**Preliminary Alternative Technical Concepts (ATC) Submittal**  
**BEL-70-9.35 Interchange Improvement**  
**Design-Build**  
**Belmont County, Ohio**  
**PID 120547**

## Contents

EXHIBIT C

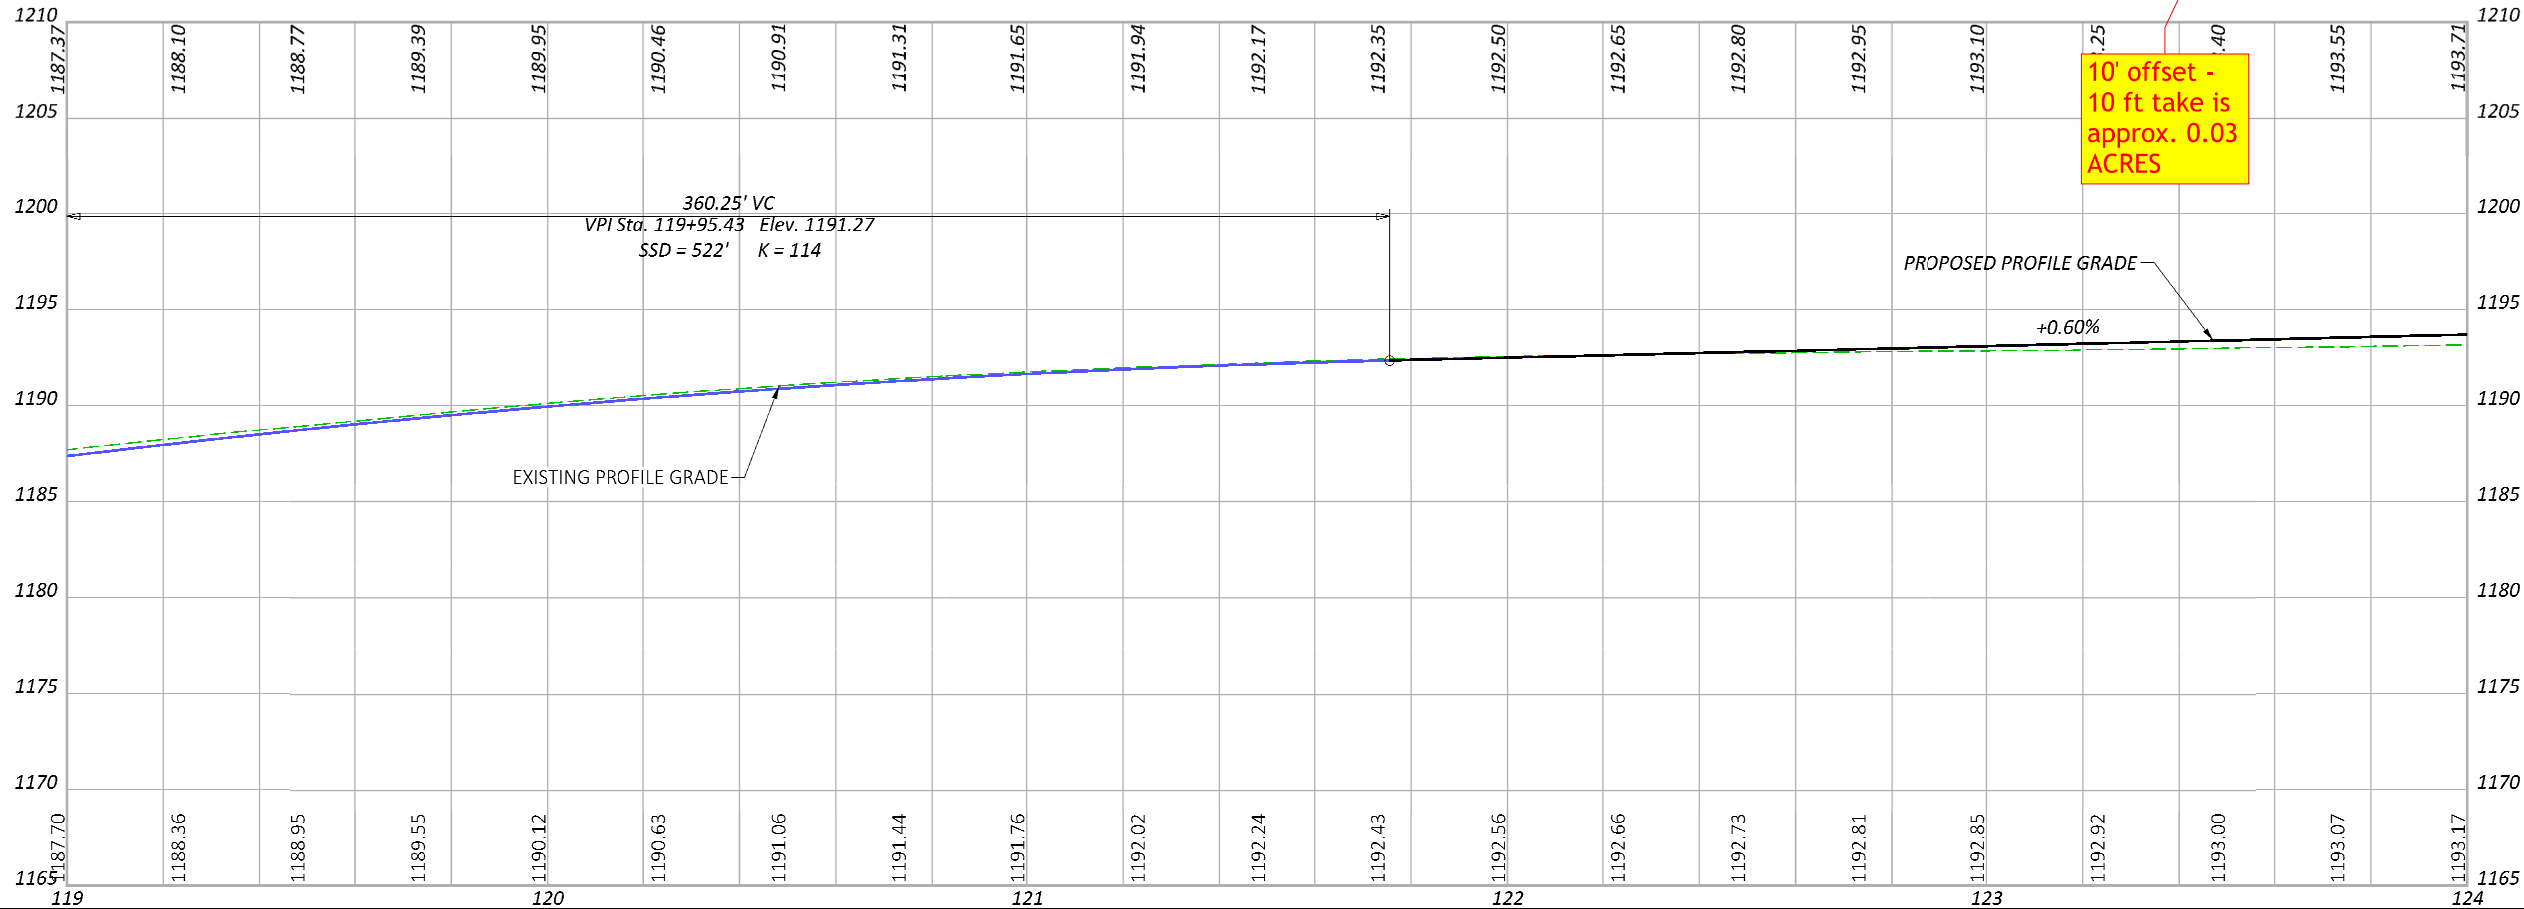
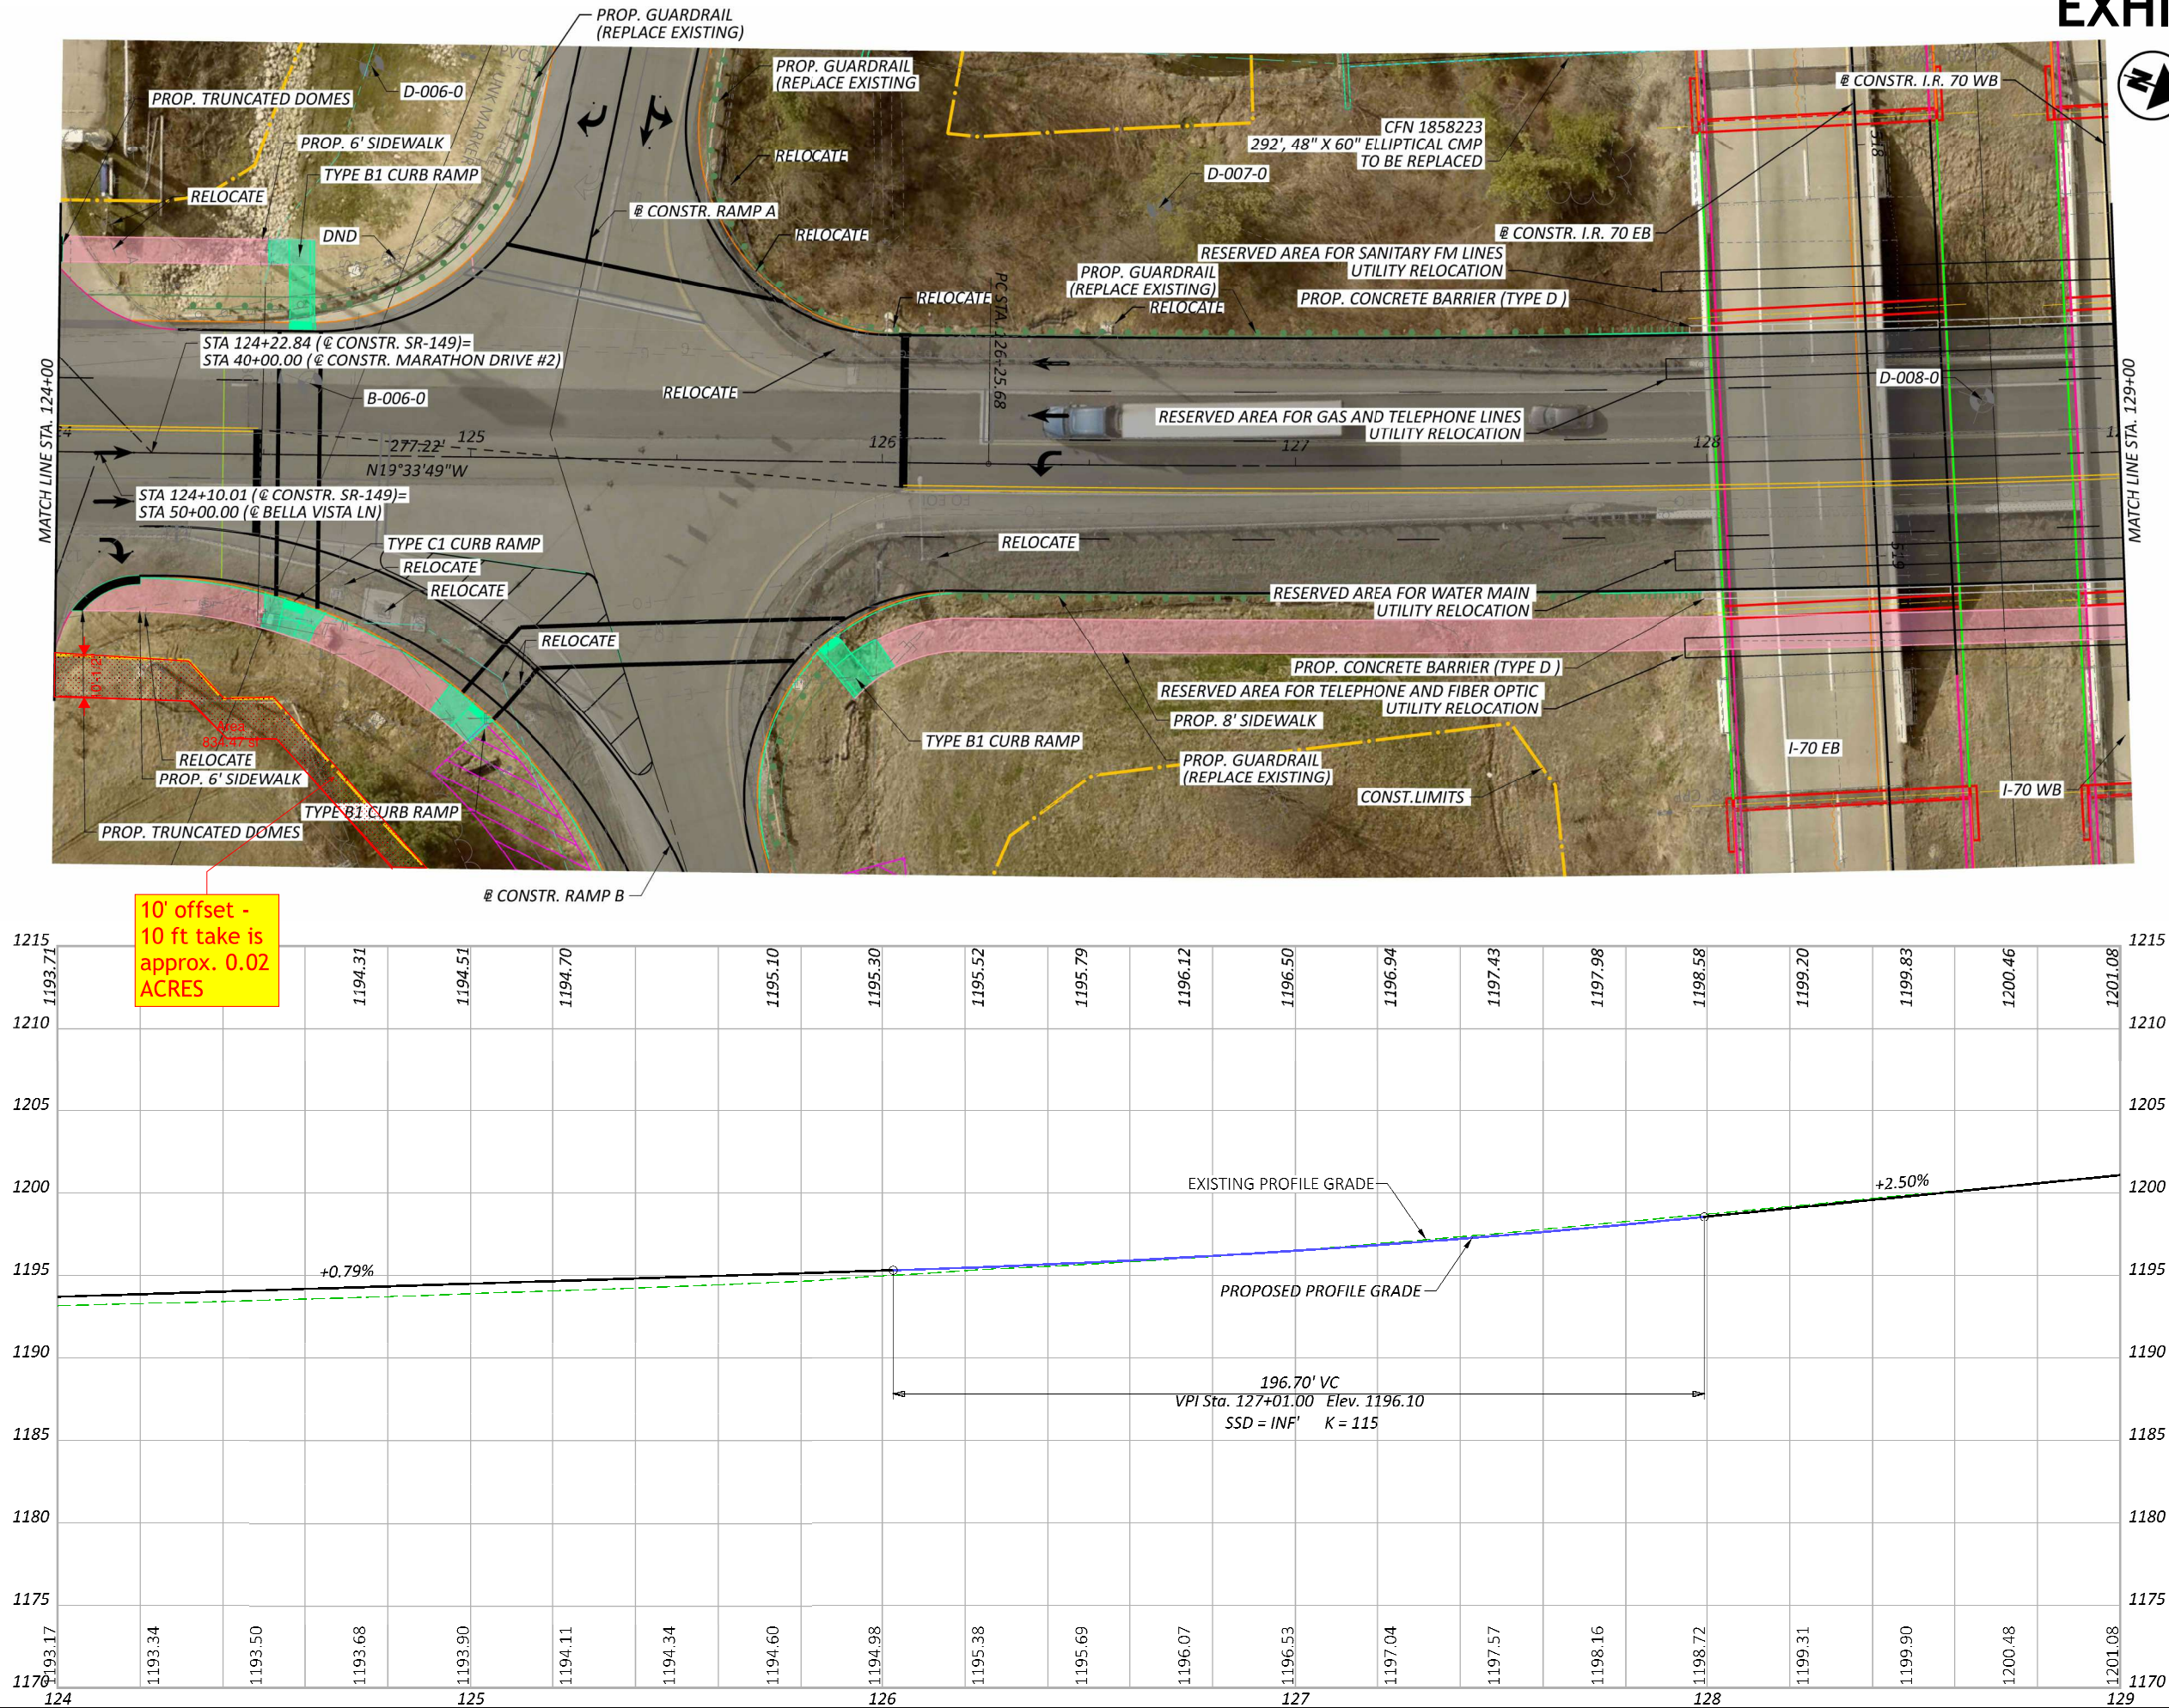
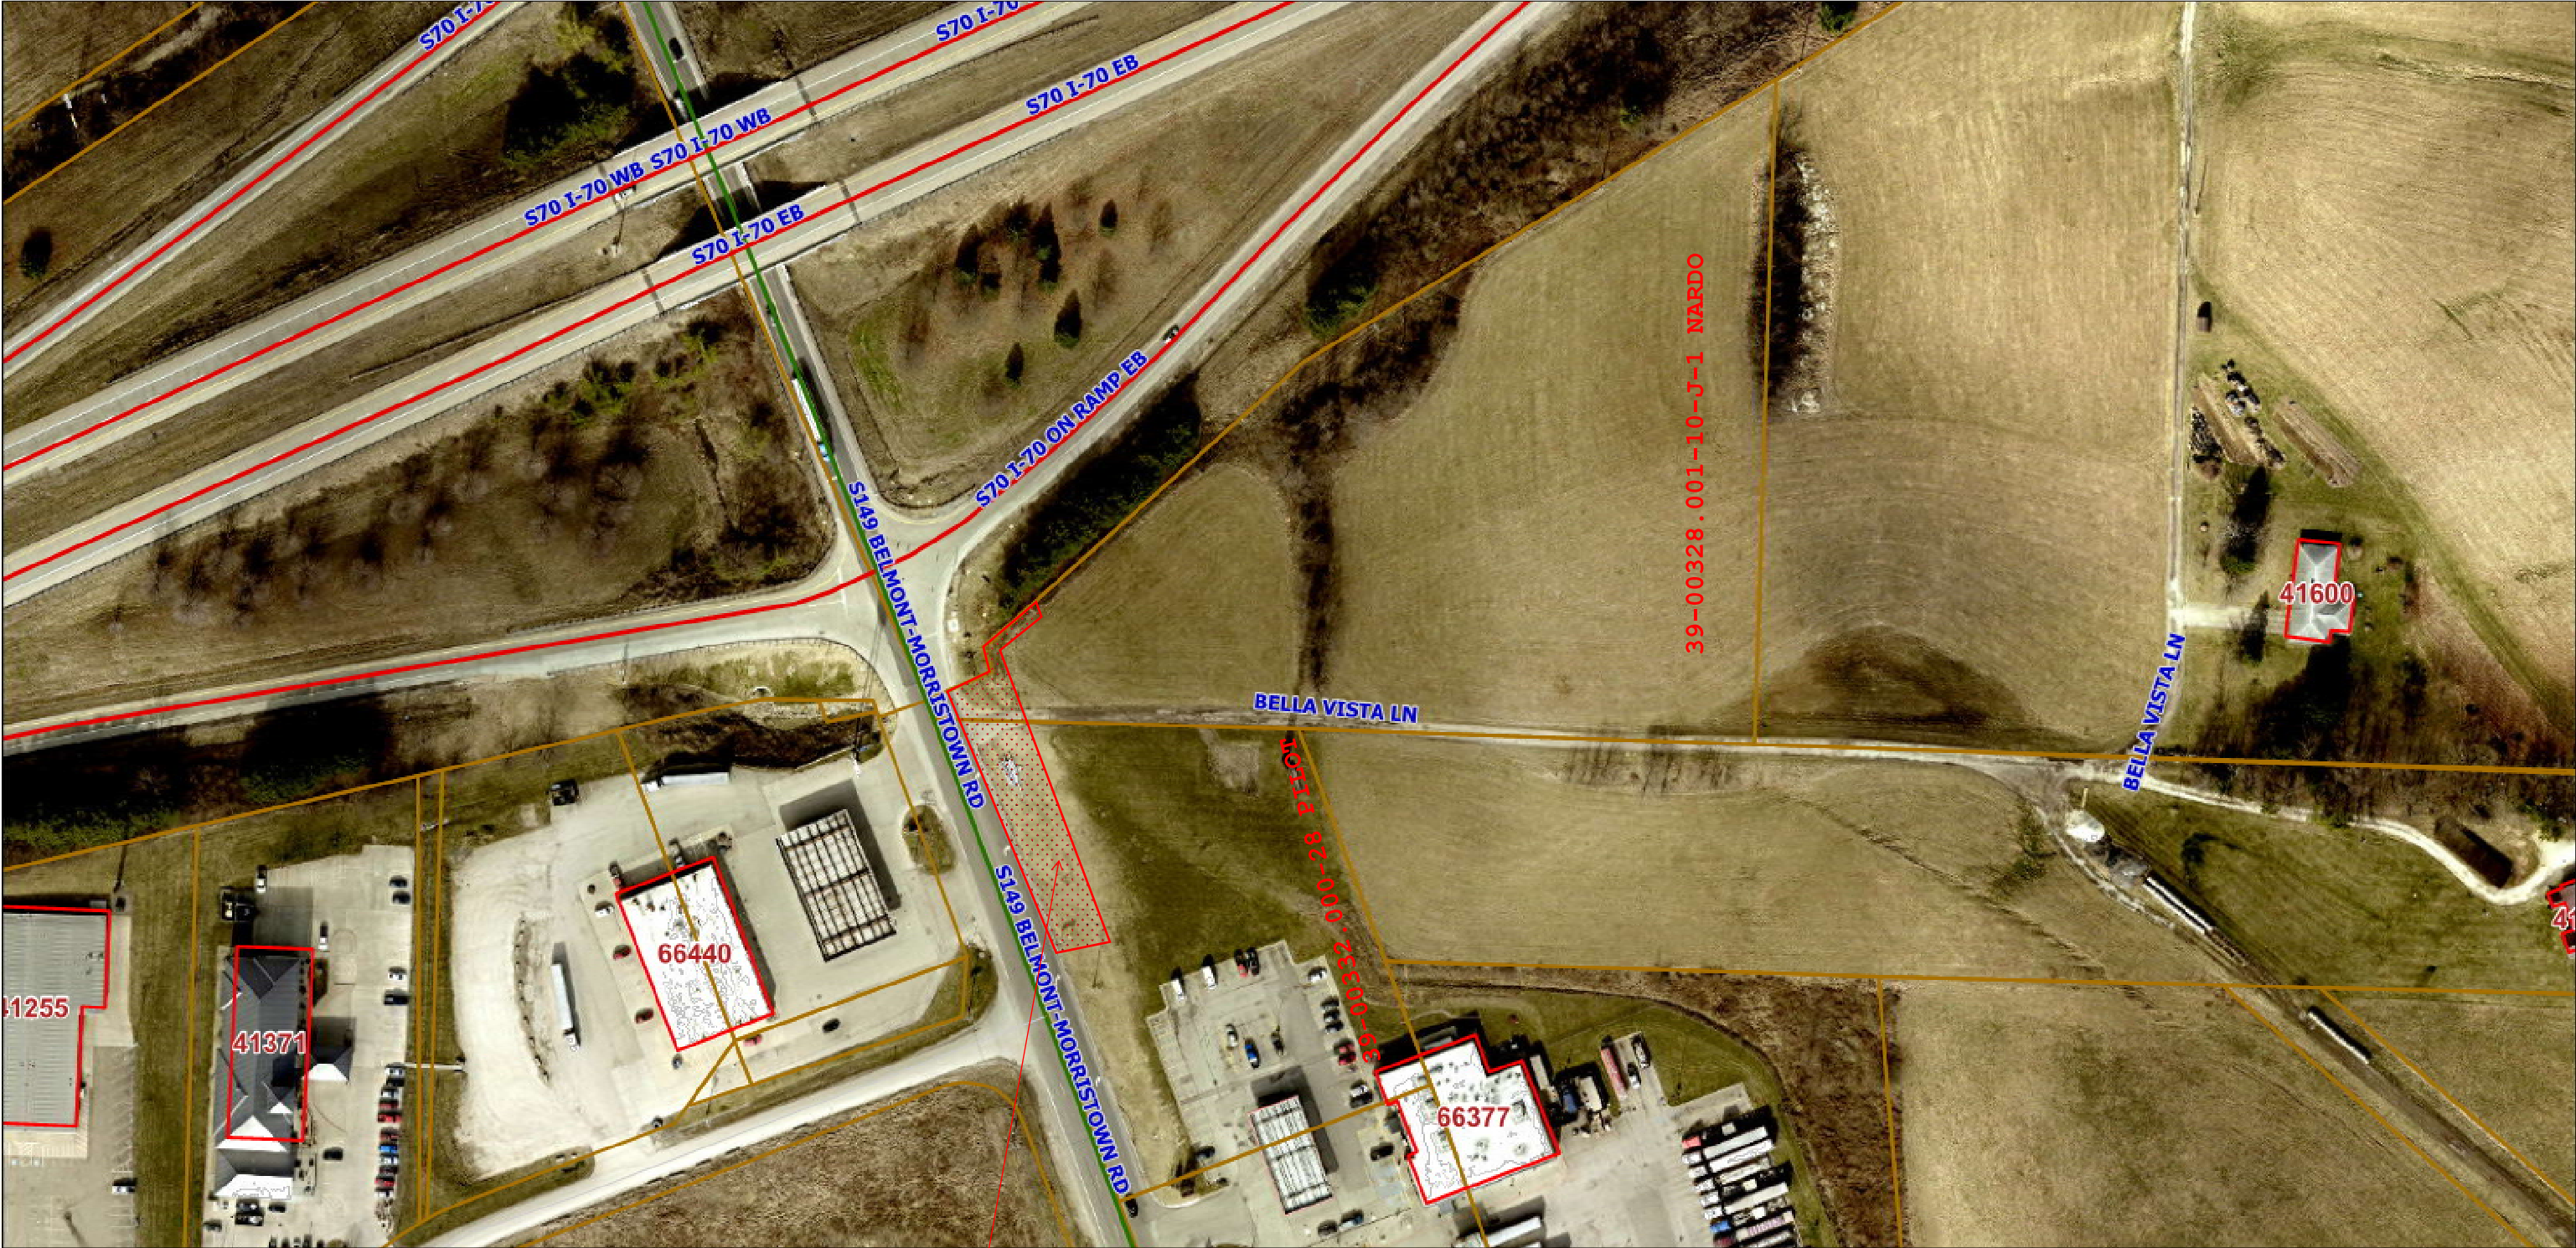
1. **Description:** This ATC proposes a modification to the Right-of-Way (ROW) acquisition requirements outlined on Page 17 of 63 of BEL-70-9.35, PID 120547 SCOPE OF SERVICES (Addendum 1). The original specification states that the Department will acquire and pay for the additional ROW needed to encompass the construction limits as shown in Appendix B Conceptual Plans.

The DBT proposes that the language specifically identify Parcel 39-00328.001 (Nardo Earle Robin & Jamie L. Surv Et Al) and Parcel 39-00332.000 (Pilot Travel Centers, LLC) as additional takes. Property Costs paid by the DBT. This modification ensures that the necessary ROW acquisitions explicitly include Parcel 39-00328.001 and Parcel 39-00332.000, which are critical to project execution. Acquiring these parcels provides additional space for construction and minimizes impacts to existing utilities and potential wetlands. This also improves the drainage function at Ramp A. See Exhibit C for additional details.

2. **Deviation:** Page 17 of 63 of BEL-70-9.35, PID 120547 SCOPE OF SERVICES (Addendum 1) states: *"The Department will acquire and pay for the additional Right of Way needed to encompass the construction limits as shown on Appendix B Conceptual Plans."*

The DBT proposes to modify the above language to: *"The Department will acquire and pay for the additional Right of Way needed to encompass the construction limits as shown in Appendix B Conceptual Plans. The DBT will reimburse ODOT for the cost of the additional take on Parcel 39-00328.001 (Nardo Earle Robin & Jamie L. Surv Et Al) and Parcel 39-00332.000 (Pilot Travel Centers LLC)."*
